ADDENDUM NUMBER TWO (2)

Project: Nancy Lopez Elementary School
1600 E. Tilden Street
Roswell, New Mexico

Date: March 22, 2024

From: PA Architects

MECHANICAL GENERAL NOTES, LEGEND AND SCHEDULES

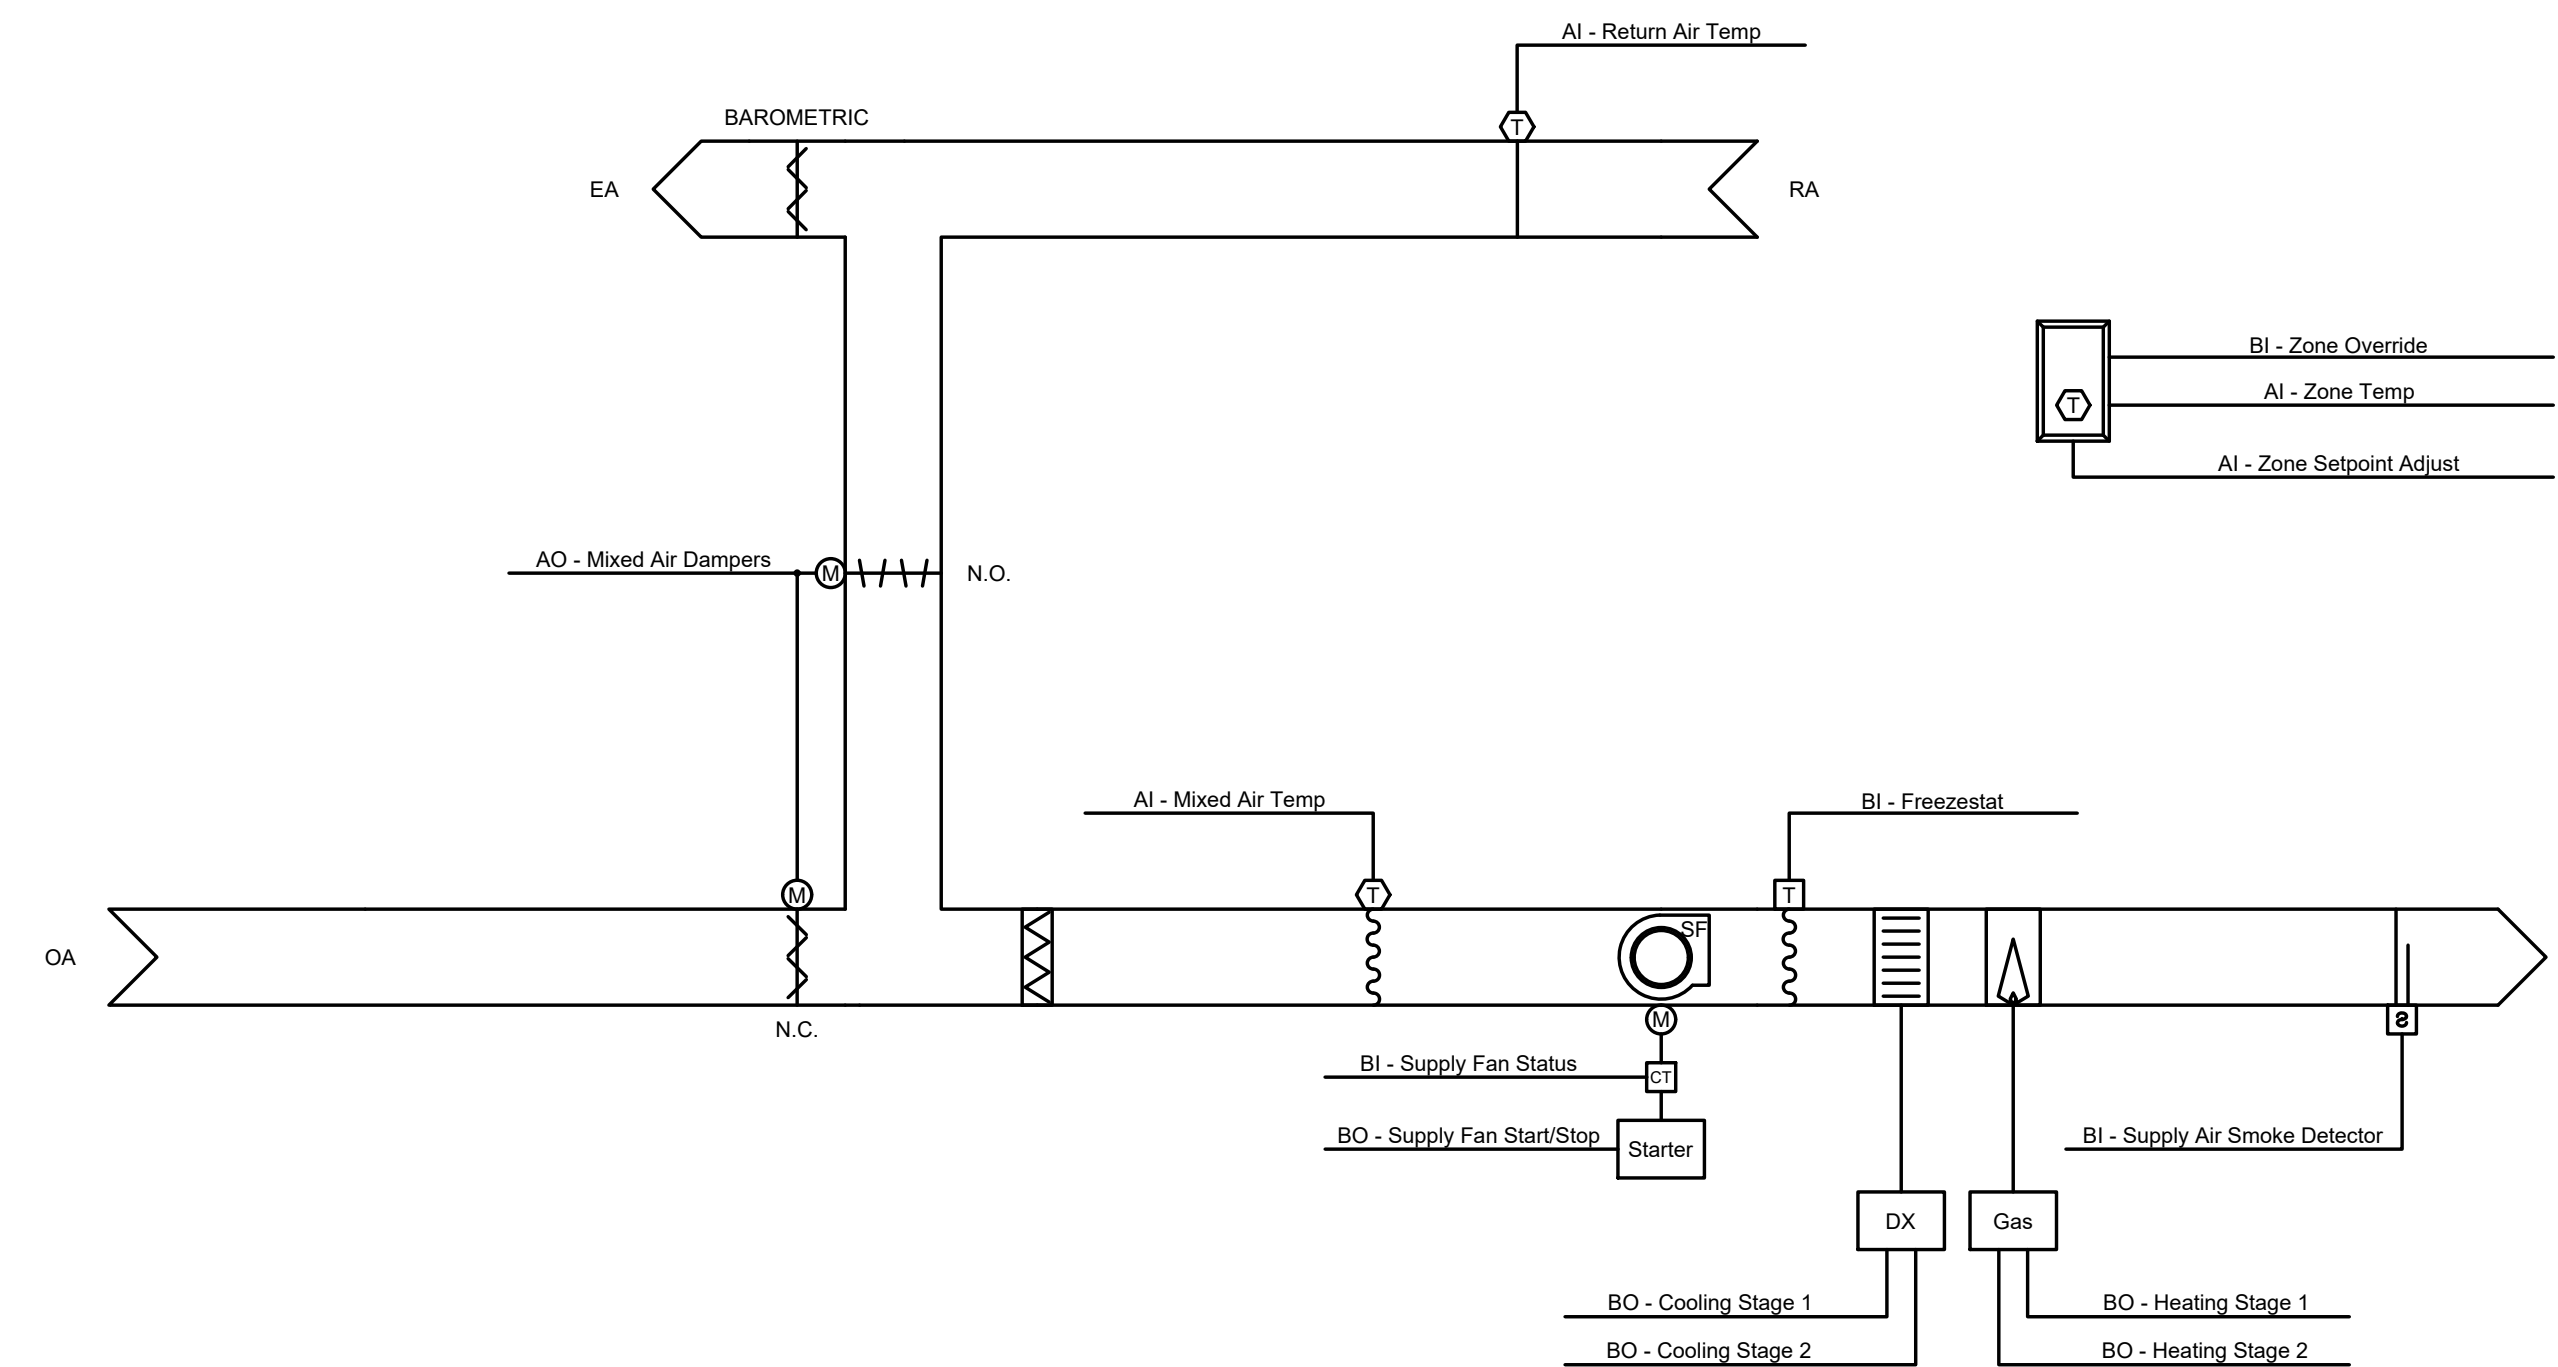
1. **CHANGES TO THE DRAWINGS:**
 - a. Delete sheet M-601 MECHANICAL GENERAL NOTES, LEGEND AND SCHEDULES. Add sheet M-601 MECHANICAL GENERAL NOTES, LEGEND AND SCHEDULES, dated 03.01.2024, attached. Note 1 on Air Distribution Device Schedule has been adjusted to make balancing damper requirements clearer.

MECHANICAL
CONTROLS

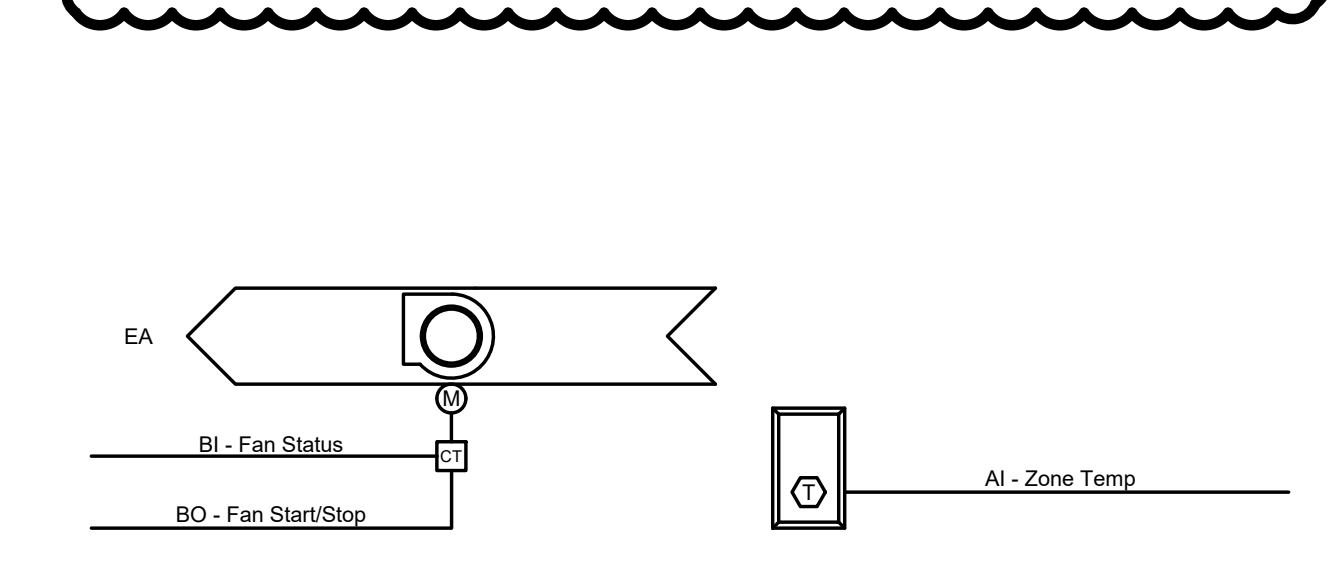
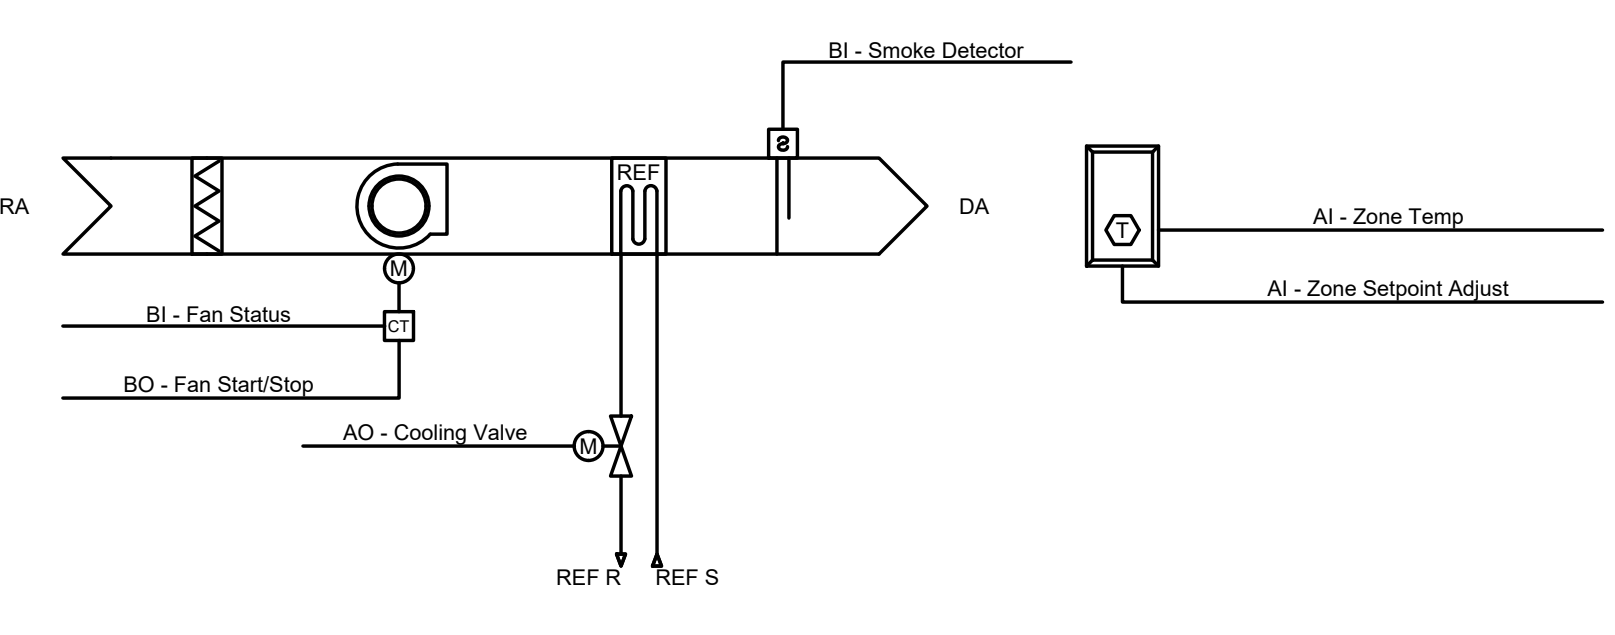
- b. Delete sheet M-701 MECHANICAL CONTROLS. Add sheet M-701 MECHANICAL CONTROLS, dated 03.01.2024, attached. The control schematics have been modified to make clear which portions of the controls are done by the zone controller and which controlled by the unit's on-board controller. The economizer will be operated by the unit's on-board controller and only get zone temperature input from the zone controller.
